Flight Procedures Cover Page	Task Action: FLIGHT CHECK	Task Type: IAP	Estimated Chart Date: 02/20/2025	APWS Task ID: 98CFEDA2A09B4C5F9366E1193E64BEB2	APWS Project ID: AF749B6EE5F94DBC49AACEB6300A073
Procedure: RNAV (RNP) Z RWY 36R AMDT 1		Enroute: NO	Specialist: Hirst, Charles		Agreement Number:
Airport ID: KCVG			Airport City: COVINGTON		State: KY
Facility ID:	Facility Type:	Flight Inspection Remark Type: New FC Slot			
<p>Procedure Comments:</p> <p>REDESIGN TO ADD RNP RF LEGS AND ADDITIONAL LEGS FOR OPTIMIZED TRAFFIC FLOW</p> <p>APPROVAL LETTERS (2):</p> <p>KCVG RNAV RNP Z RWY 36R: BRCAT MANDATORY ALTITUDE</p> <p>KCVG RNAV RNP Z RWY 36R: RUPPP MANDATORY ALTITUDE</p> <p>FOR ADDITIONAL INFORMATION CONTACT ERIC SUSKI, MANAGER 405-954-7331</p> <p>12/03/2024: THIS IS AN UPDATED COPY OF THE FORM DEVELOPED ON 11/06/2024.</p> <p>8260-2: BAIRE</p> <p>FIX USE: DELETED IAP RNAV (GPS) Y RWY 36R AT KCVG.</p> <p>8260-2: KYKAT</p> <p>EXPANDED SERVICE VOLUME (ESV): CHANGED DISTANCE FROM 21 TO 22.</p> <p>8260-2: NUYLI</p> <p>FIX MAKE-UP FACILITIES: CHANGED FAC 1 MAG/TRUE BRG FROM 186.21/180.21 TO 180.20/180.20 AND MAA FROM 5000 TO 5300.</p> <p>EXPANDED SERVICE VOLUME (ESV): REMOVED I-EEI R-186 ES

CINCINNATI/NORTHERN KENTUCKY INTL
KCVG
RNAV RNP Z RWY 36R AMDT 1
1:500,000
BRCAT & RUPPP INTERMEDIATE, FINAL
AND MISSED

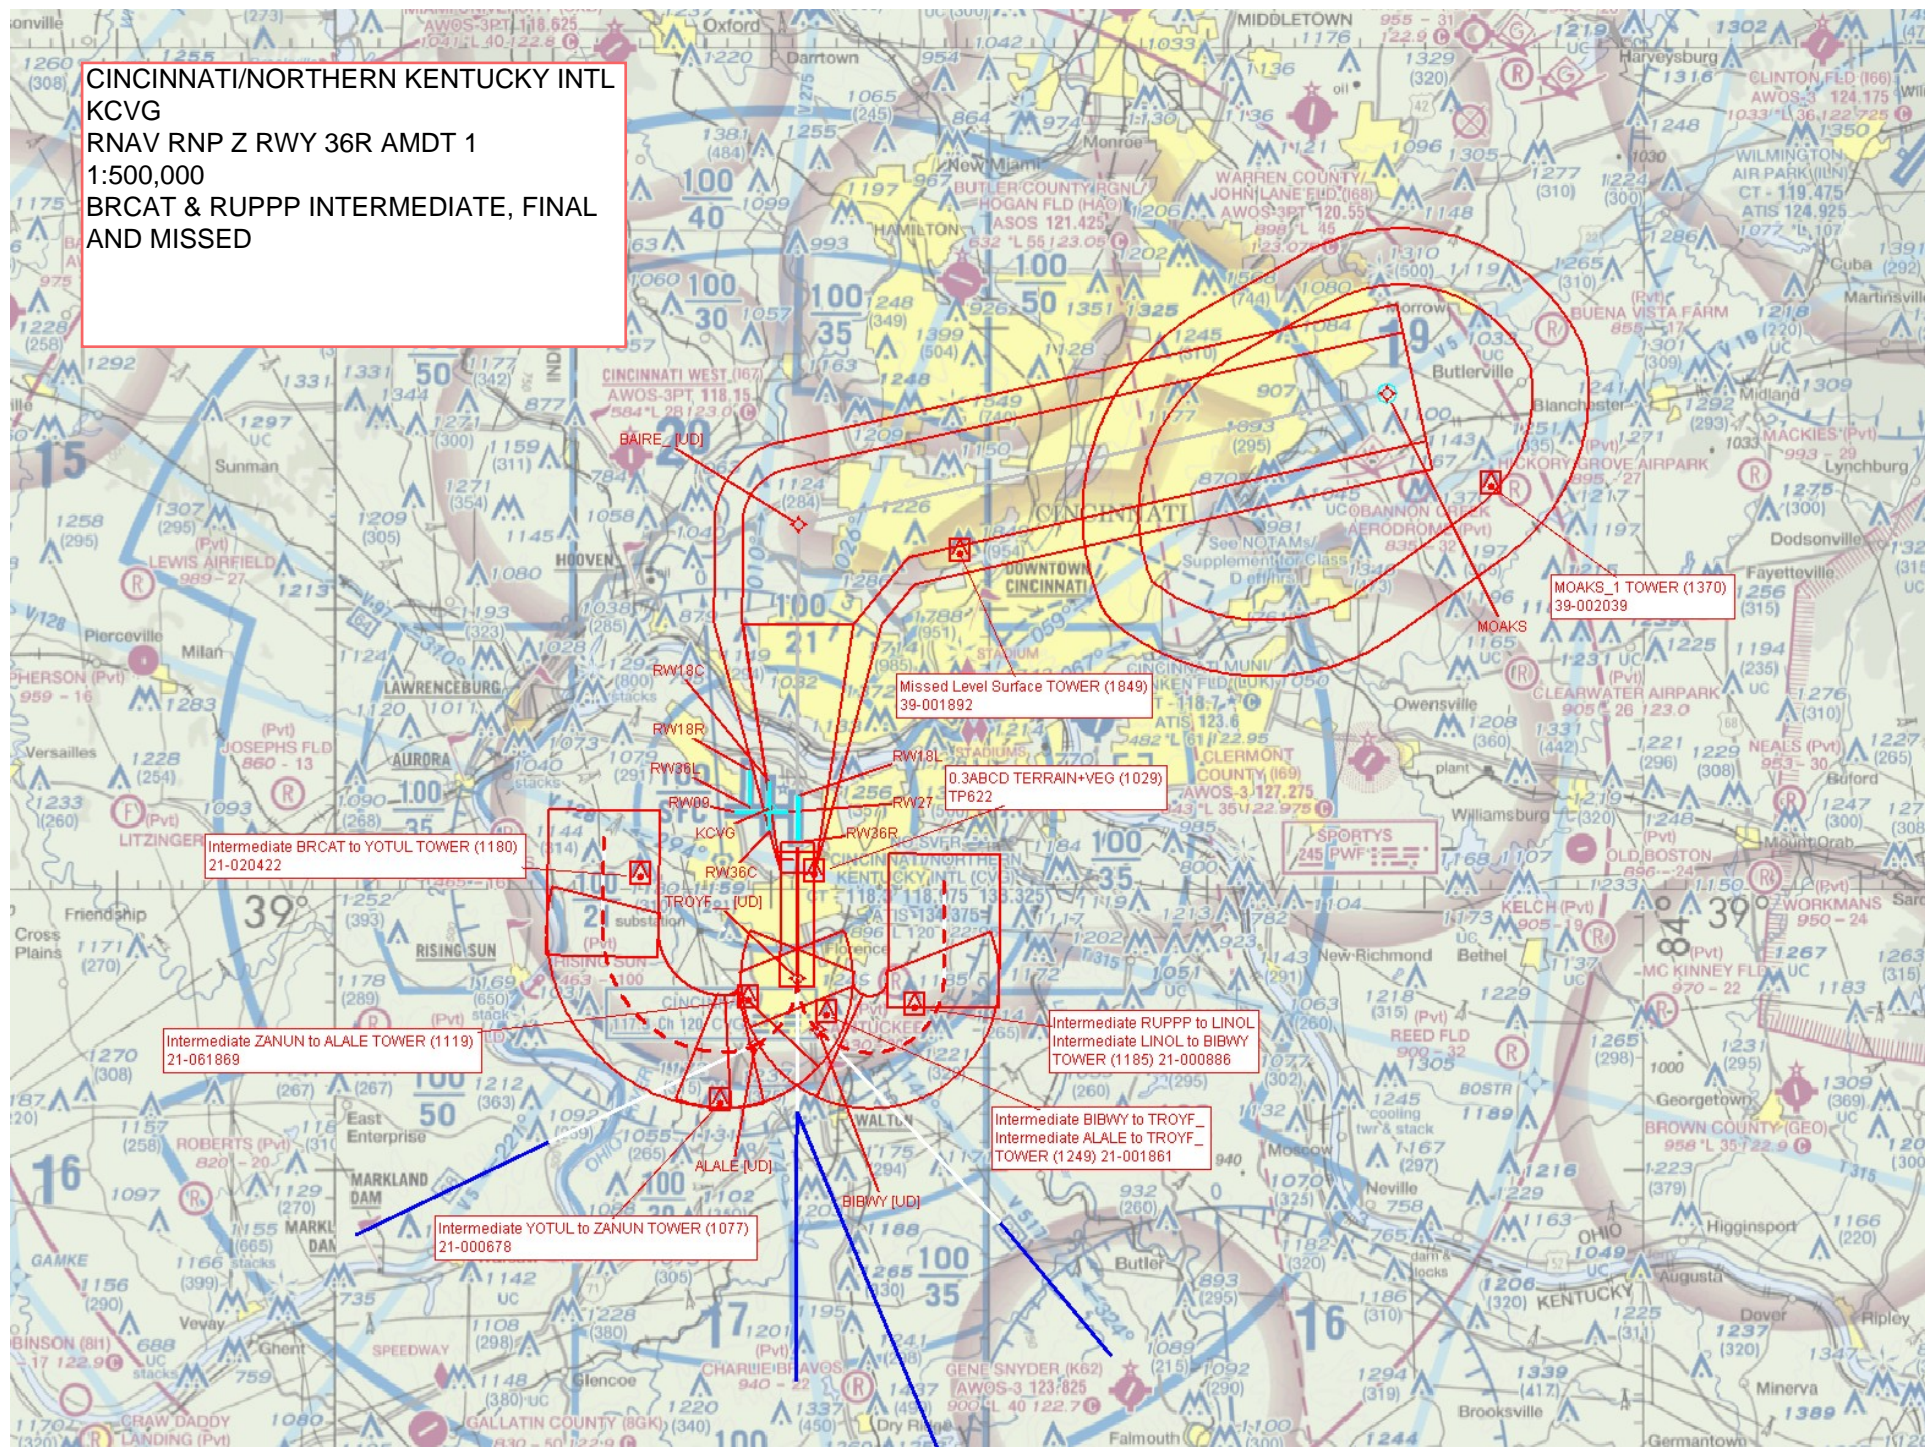
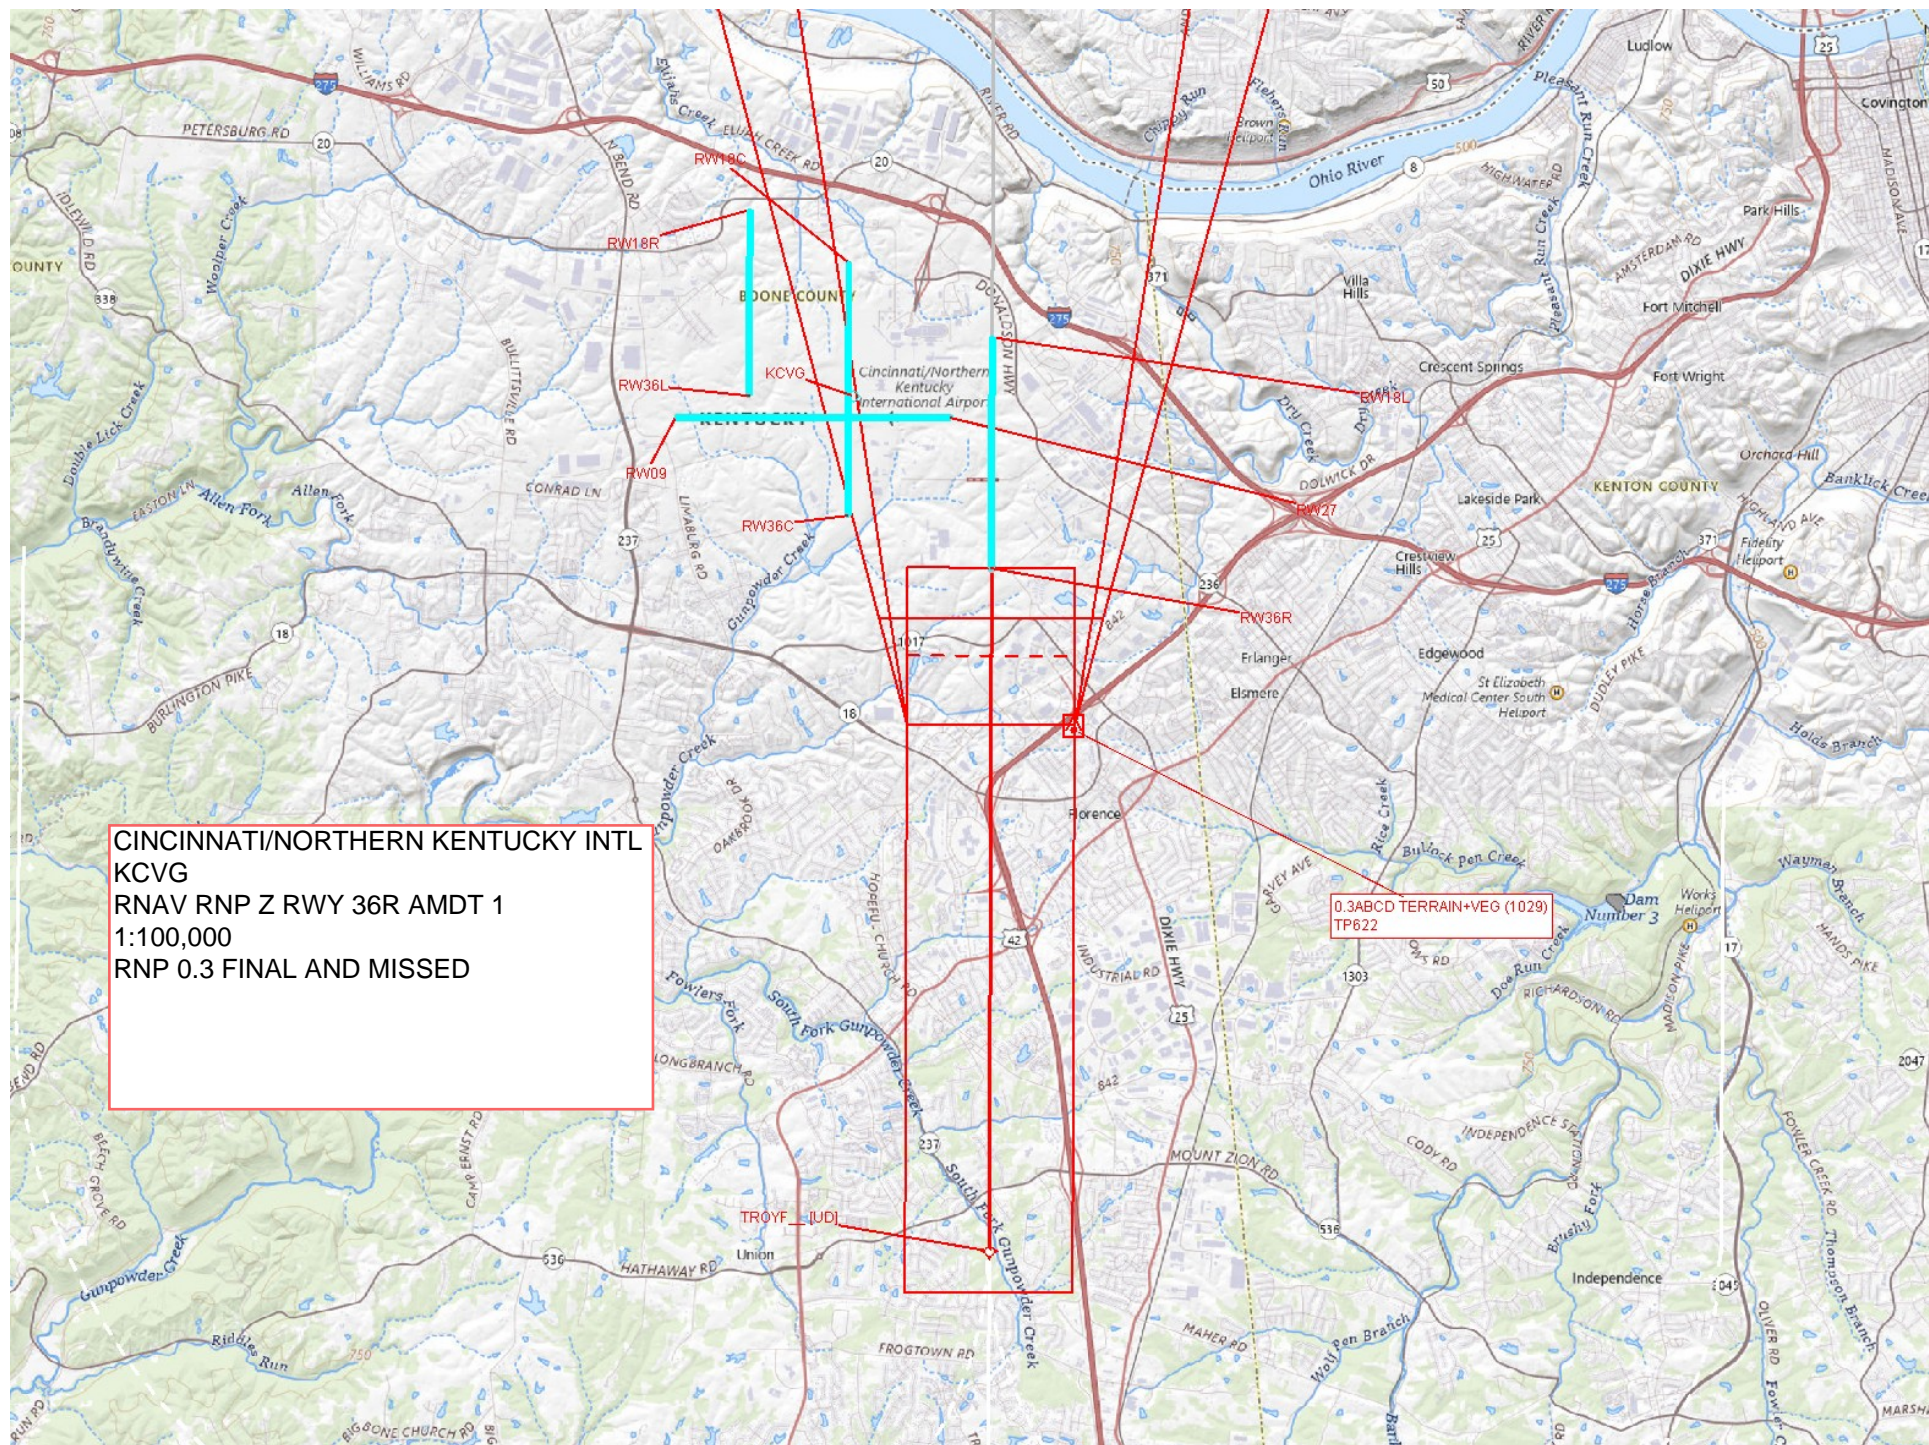
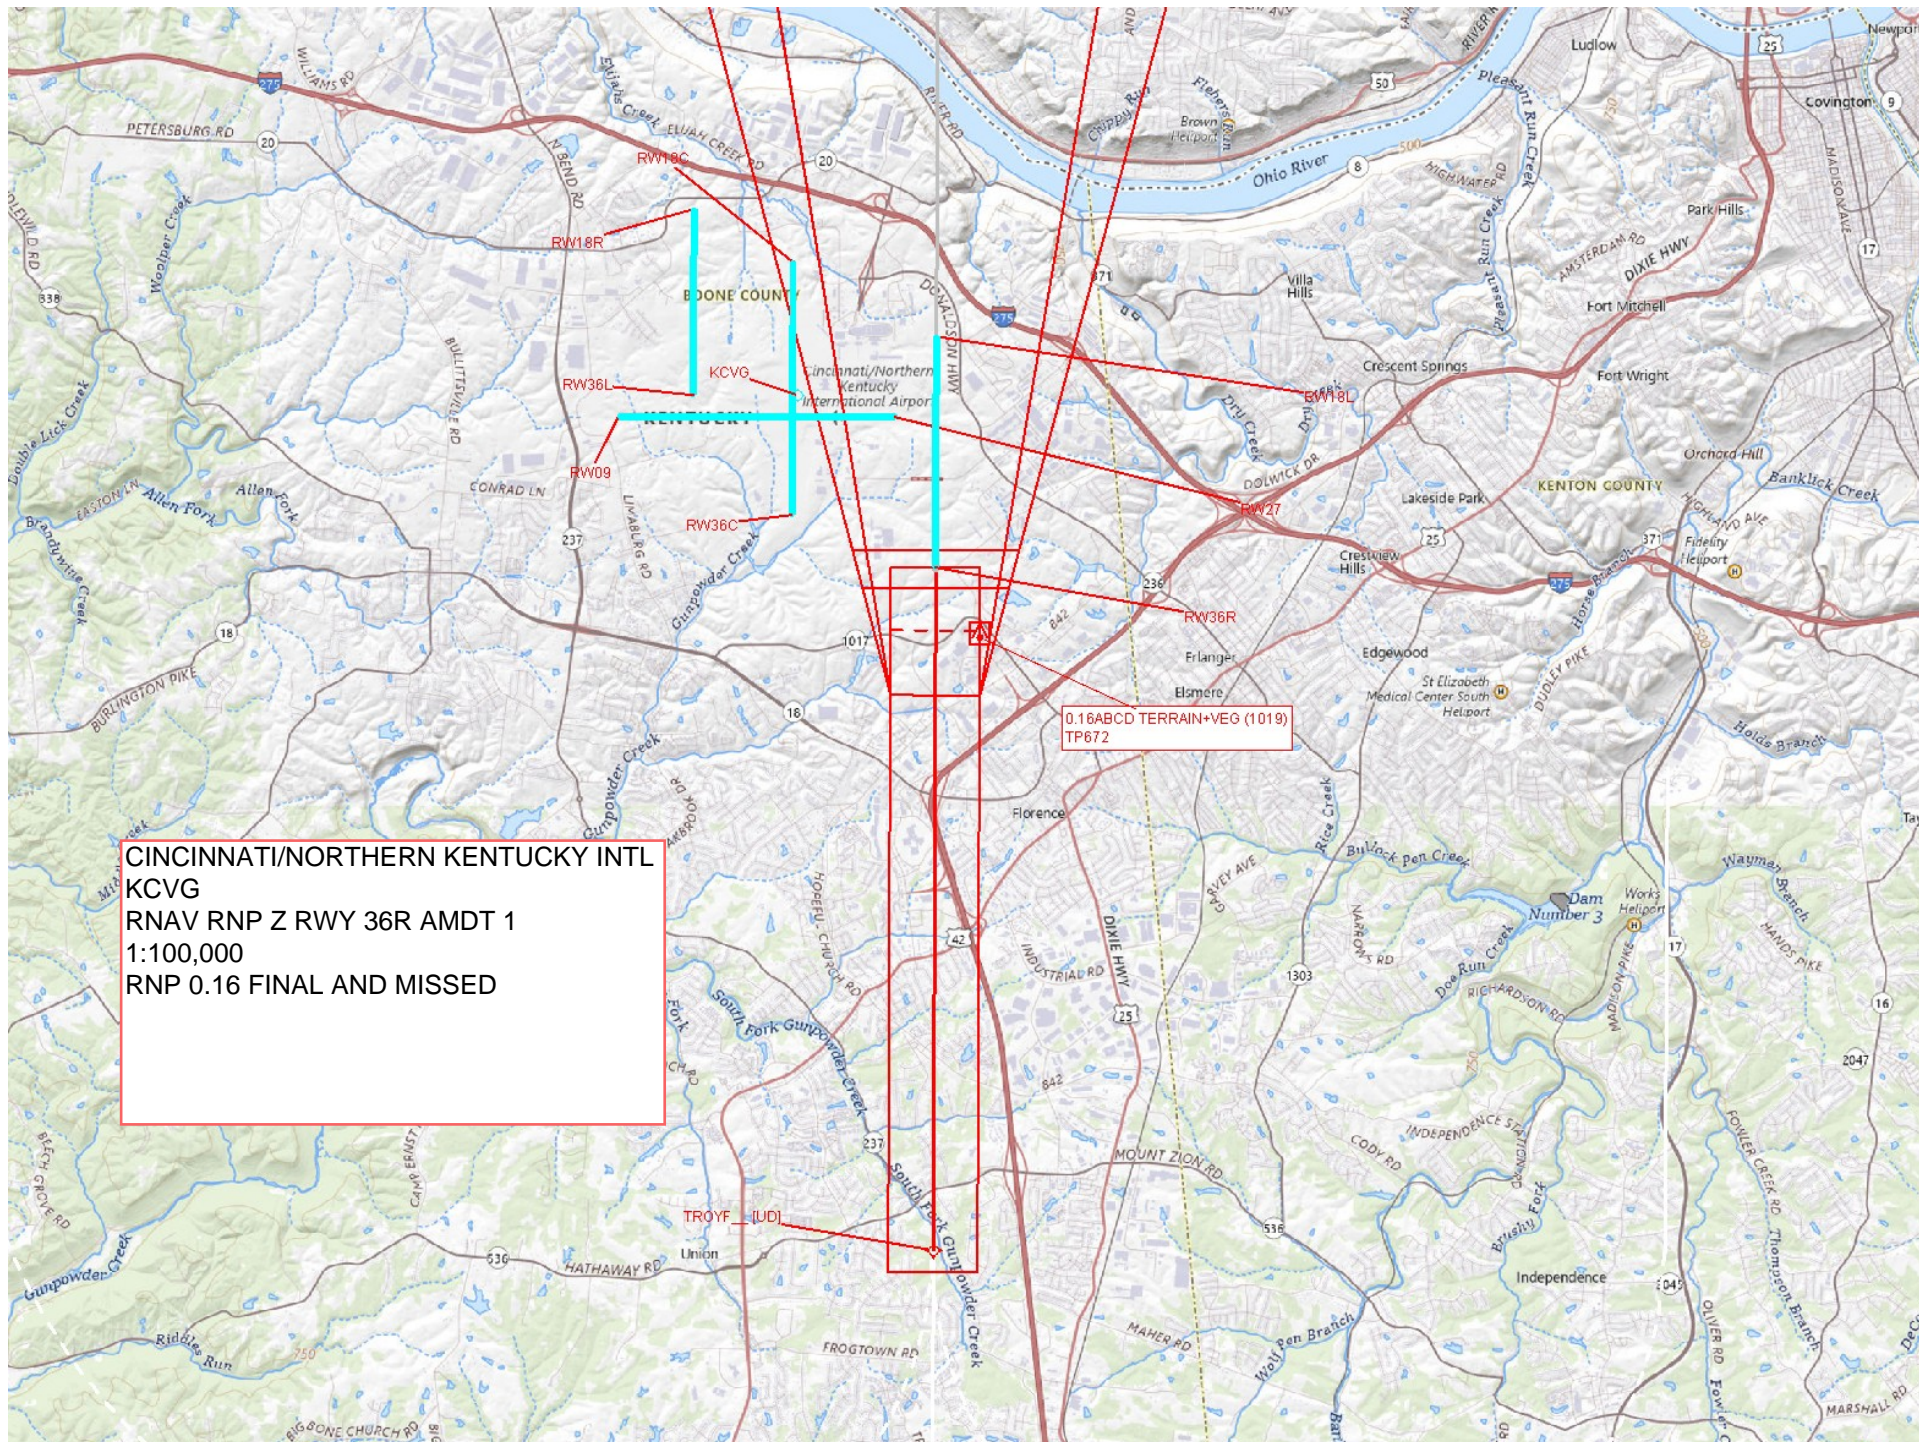
KCVG TRACON requests AFS approval to chart a mandatory altitude restriction at the following fix: BRCAT at 6000ft MSL for RNAV RNP Z RWY 36R instrument approach procedure for Cincinnati-Northern Kentucky International Airport (KCVG).

Currently, FAAO 8260.19I paragraph 8-6-10n (1) requires Flight Standards approval from the Flight Technologies and Procedures Division to chart a mandatory altitude on the intermediate segment of an instrument approach procedure.

Therefore, Cincinnati TRACON requests to chart the mandatory restriction at BRCAT RNAV RNP Z RWY 36R. This is an ATC operational request to ensure vertical separation between aircraft on the approach and other TRACON traffic.

KCVG TRACON requests AFS approval to chart a mandatory altitude restriction at the following fix: RUPPP at 6000ft MSL for RNAV RNP Z RWY 36R instrument approach procedure for Cincinnati-Northern Kentucky International Airport (KCVG).

Currently, FAAO 8260.19I paragraph 8-6-10n (1) requires Flight Standards approval from the Flight Technologies and Procedures Division to chart a mandatory altitude on the intermediate segment of an instrument approach procedure.

Therefore, Cincinnati TRACON requests to chart the mandatory restriction at RUPPP RNAV RNP Z RWY 36R. This is an ATC operational request to ensure vertical separation between aircraft on the approach and other TRACON traffic.

Your request to chart a mandatory crossing altitude of 6000 feet at BRCAT on the "RNAV (RNP) Z RWY 36R, AMDT 1" at Cincinnati/Northern Kentucky Intl, Covington, KY was discussed at the Flight Standards Procedure Review Board on 12/21/2023 and is approved.

Your request to chart a mandatory crossing altitude of 6000 feet at RUPPP on the "RNAV (RNP) Z RWY 36R, AMDT 1" at Cincinnati/Northern Kentucky Intl, Covington, KY was discussed at the Flight Standards Procedure Review Board on 12/21/2023 and is approved.
